Delegated Decision Report

Application No:	25/0152	Statutory Period Expires:	06 July 2026
Site:	<i>Glan Llyn Development Site Phase 4E / 4G Queensway Llanwern Newport South Wales</i>		
Proposal:	<i>RESERVED MATTERS APPLICATION RELATING TO LAYOUT, SCALE, APPEARANCE, ACCESS AND LANDSCAPING FOR RESIDENTIAL DEVELOPMENT AT PHASE4E/4G PURSUANT TO OUTLINE PLANNING PERMISSION 06/0471 FOR A MIXED USE REGENERATION OF THE FORMER LLANWERN STEELWORKS AND PARTIAL DISCHARGE OF CONDITIONS 01 (RESERVED MATTERS), 06 (RECREATIONAL AREAS), 08 (MATERIALS), 09 (DETAILS OF HARD LANDSCAPED ACCESS), 10 (BOUNDARY TREATMENTS), 11 (MANAGEMENT STRATEGY FOR MAINTENANCE OF OPEN SPACE), 12 (OFF STREET PARKING AND CYCLE PARKING), 15 (EMERGENCY ACCESS), 16 (DETAILS OF ROADS/CYCLEWAYS/FOOTWAYS), 18 (ESTATE ROADS), 22 (STREET LIGHTING AND CAR PARKING AREAS), 24 (SITE LEVELS), 33 (SURFACE WATER DISPOSAL, 34 (FOUL AND SURFACE WATER DRAINAGE), 39 (SUSTAINABILITY STATEMENT) AND 43 (FIRE FIGHTING ACCESS)</i>

Applicant:	Miller Homes		
Type:	Reserved Matters (Major)	Ward:	Llanwern
Decision:	Part Approved & Conditions / Part Refused

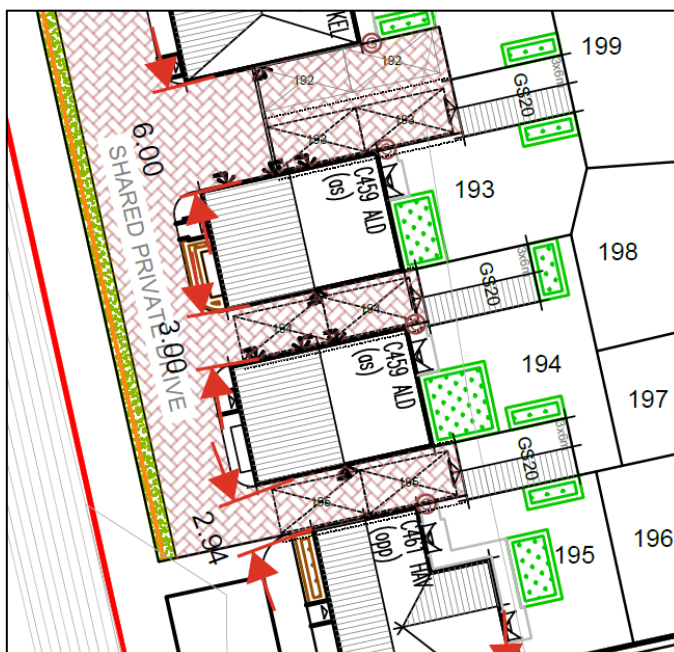
- 8.9 Other aspects of the layout shown 'tightness', this run for example showing parking spaces between units. These should be 3.3m (2.4m for the space and 0.9m for the 'footway' – Parking SPG, Appendix 2, with the footway shared between adjacent units as required):

- 8.10 This pattern is generally consistent with parking spaces between houses being shaved by typically 20-30cm within the layout. This will reduce the utility of parking spaces and is not policy compliant and will certainly prejudice less mobile persons and make it more difficult to adjust child seats for example (typical child friendly parking space being 3.2m¹ wide versus the 3.3m requirement for space and footway). However these spaces will be usable for the average person despite their constriction. Nevertheless this is a failure to comply with adopted Policy and it is indicative of 'stress' within the layout and it weighs against the proposal.
